MARYLAND DOT - STATE HIGHWAY ADMINISTRATION
Office of Traffic & Safety
TRAFFIC ENGINEERING DESIGN DIVISION

MD 528 (COASTAL HIGHWAY) AND 65th ST.

TOD No. AT909-32
SHA No. WO442A55/C55

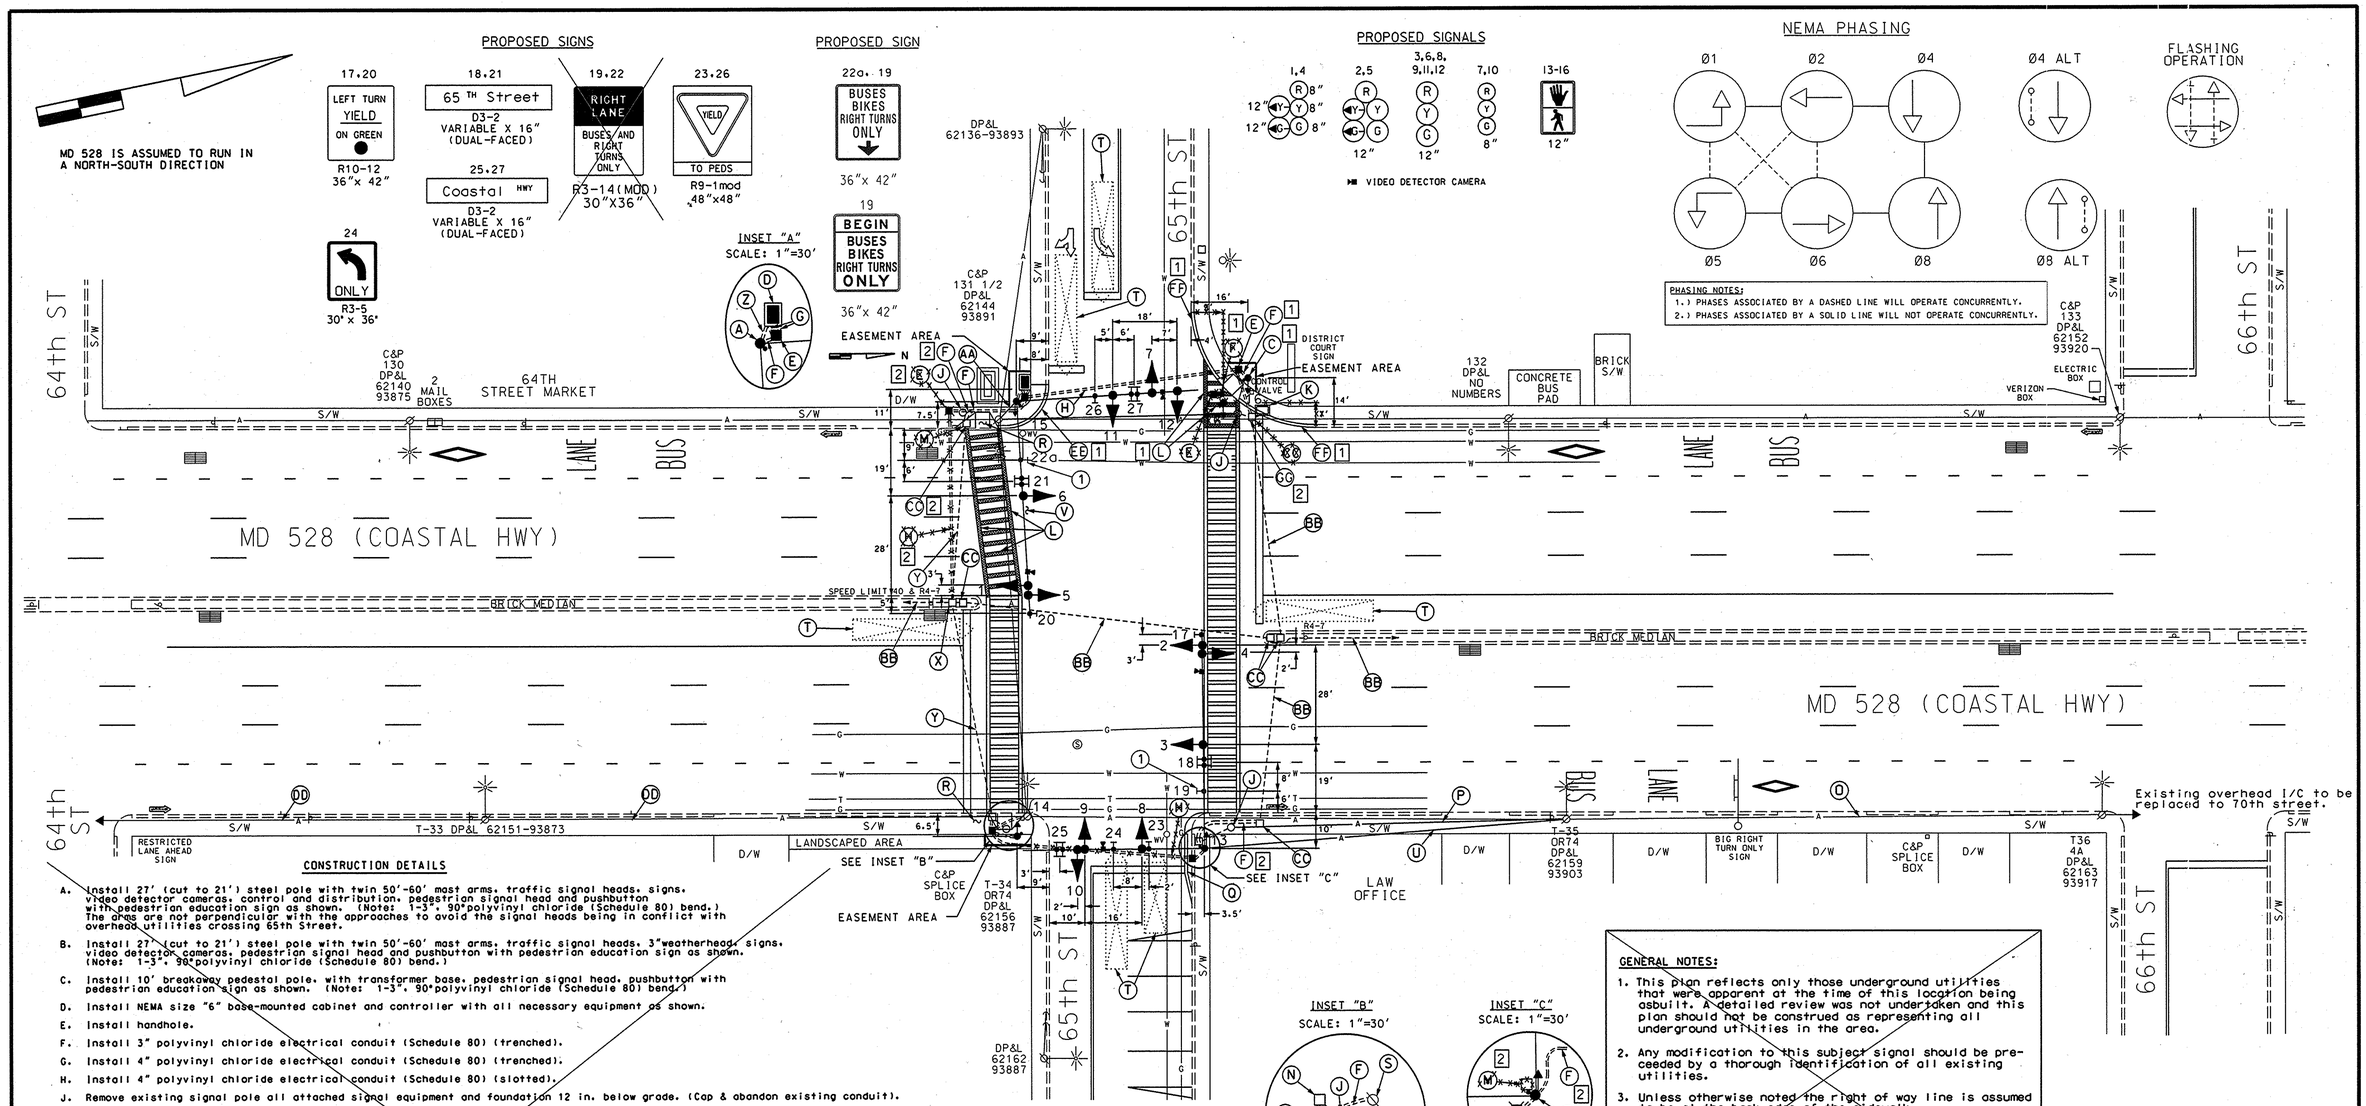
2 S. Install 2"X" weatherhead and 2"X" PVC Schedule 80 riser onto existing utility pole. Attach elbow at pole base. Pullback existing overhead interconnect cable from controller to this utility pole and reroute thru proposed conduit into proposed controller.

1 EE. Remove existing sidewalk and curb and gutter and install curb and gutter with a 12' radius as shown. Install new sidewalk.

1 FF. Remove existing sidewalk and curb and gutter and install curb and gutter with a 35' radius. Install new sidewalk and handicapped ramp as shown.

2 GG. Remove existing handhole and extend existing conduit from this handhole to proposed handhole as shown.

1 REMOVE EXISTING LANE RESTRICTION SIGN AND INSTALL NEW SIGN AT SAME LOCATION ON MAST ARM AS SHOWN.
